TRANSPORT ASSESSMENT

PROPOSED INDUSTRY DEVELOPMENT

LOT 6 FRANKLIN STREET, YARRABILBA QLD

(RESPONSE TO EDQ INFORMATION REQUEST
DATED 26 MARCH 2025)

FIGURE 3.1 – PROPOSED SITE PLAN

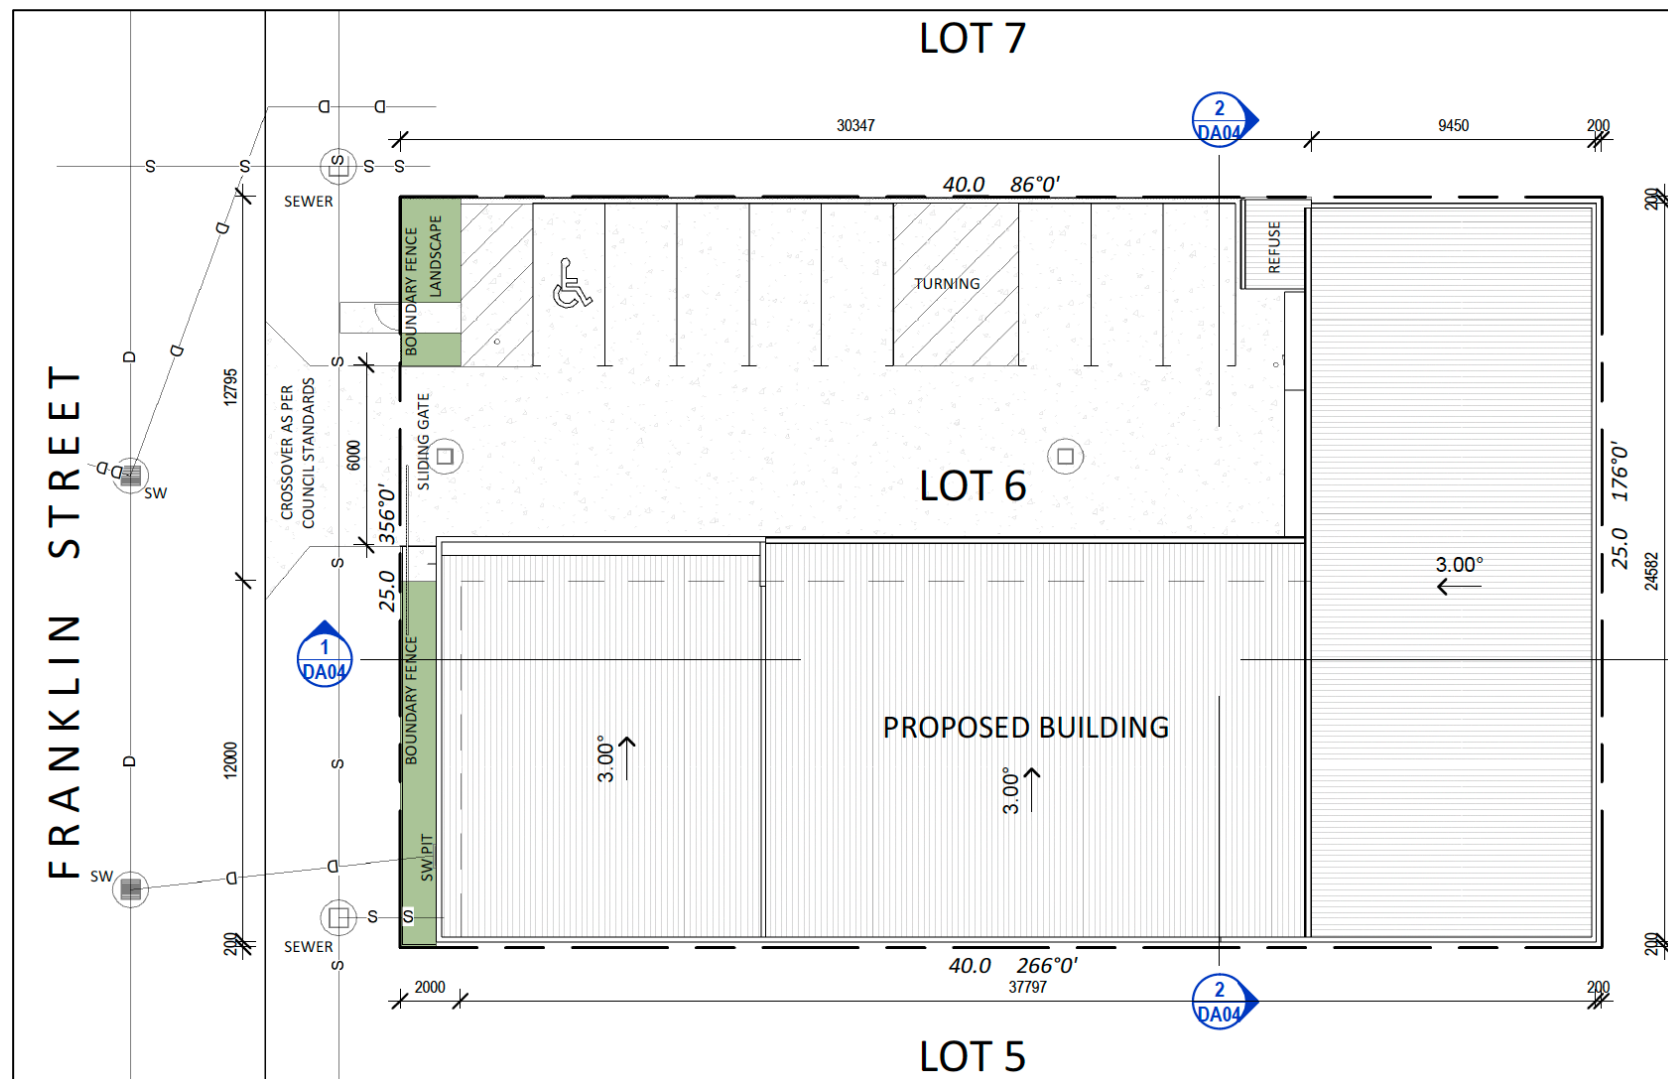
- 1) Provide amended plans:
 - demonstrating a car parking rate in accordance with the approved POD, all car parking spaces are to be located outside of each warehouse.

- showing all pits and/or grates in trafficable areas to have Class D trafficable grate/lids. Alternatively, EDQ DA can amend the plans in red.
 - bay widths of the PWD swapped with the shared space, alternatively, EDQ DA can amend the plans in red.

- providing further detail on the refuse area roof height and the extent of intrusion into the PWD bay.
- 2) Provide written confirmation the refuse area roof achieves compliance against the National Construction Code requirements for PWD car spaces.

- a. The proposed plan of development has been amended to include all car parking spaces located outside of each warehouse, in accordance with the approved POD. Refer to Figure 3.1.
- b. The proposed plan of development has been amended to include Class D trafficable grate/lids for all pits and/or grates located in trafficable areas.
- c. The PWD and shared space widths have been provided in accordance with AS2890.6:2004. Refer to Figure 3.1.
- d. The refuse area is no longer proposed next to the PWD space.
